Re: Responses to Comments on the KUCC Final Design for Remedial Action at South Facilities Groundwater

**RE: KUCC Response to UDEQ Comments on the document entitled Kennecott Utah Copper Corporation Final Design For Remedial Action at South Facilities Groundwater, dated December 2002.**

# KENNECOTT UTAH COPPER WATER MITIGATION PLAN

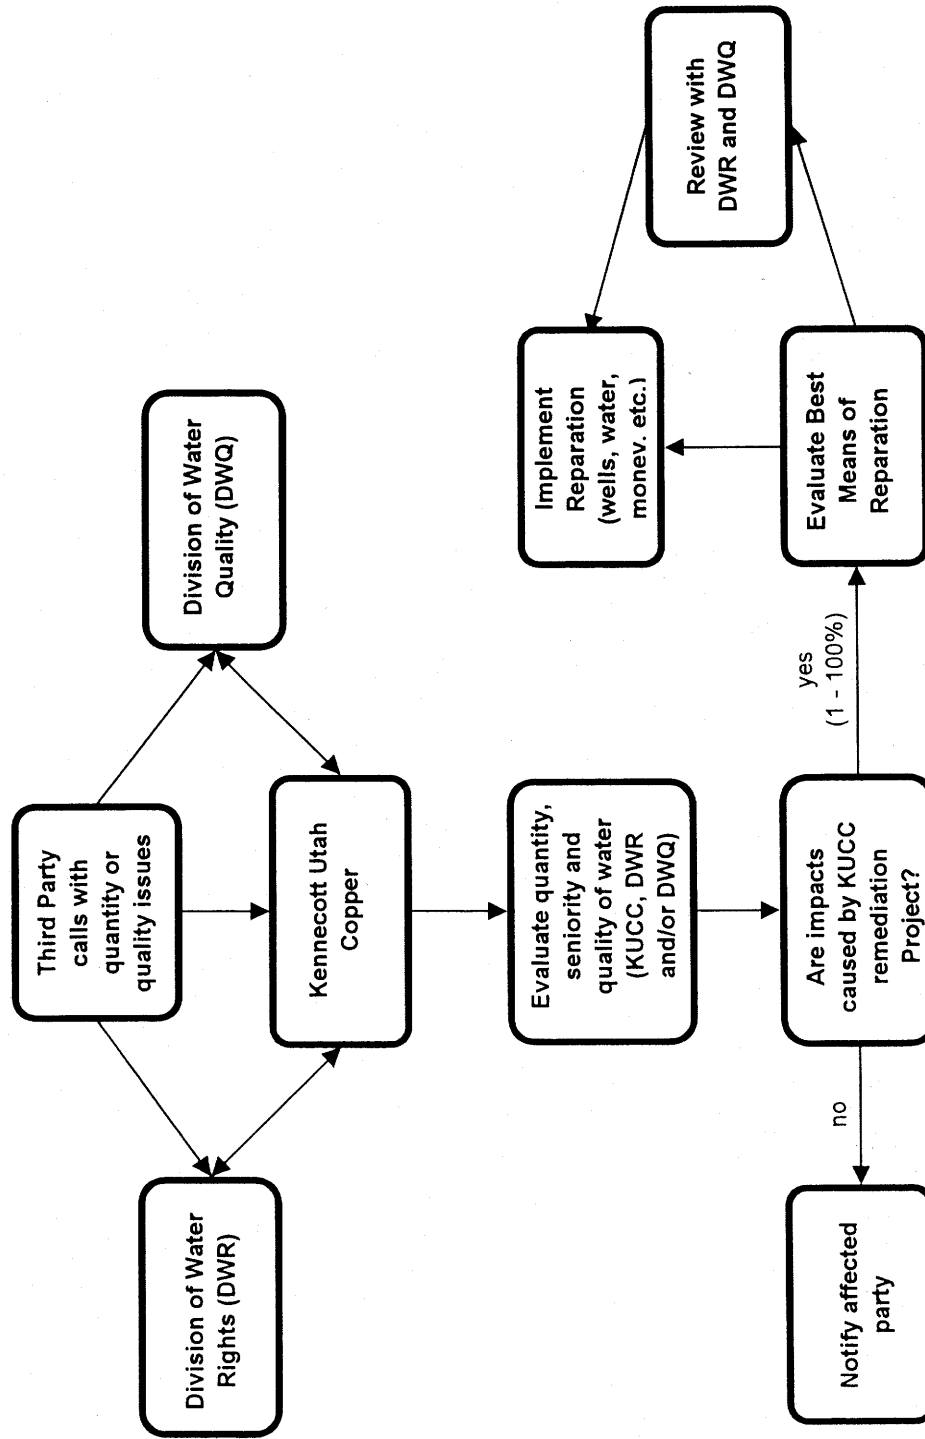
(2) On page 71, Figure 4-1 Water Rights Management Plan provides a flow chart to demonstrate how water draw down issues will be managed between KUCC, the State Engineer, and the affected water right holder. A similar diagram was supposed to be included to demonstrate how water right holders (well users) would be assisted if their well water is affected by contaminants associated with both plumes. The State NRD Trustee (Director of UDEQ) or her designee was to be the point of contact during the assessment between KUCC and the affected party. Please describe and include a flow chart on how parties affected by the contamination from the two plumes will be assisted.

(12) Page 71, Figure 4-1 Water Rights Management Plan: Please label the decision point arrows from the box entitled "Are impacts caused by KUCC Remediation Program."

A revised flow chart describing water quality and quantity determinations and resolutions is attached to this letter.

A revised flow chart describing water quality and quantity determinations and resolutions is attached to this letter (see response to general comment No. 2).
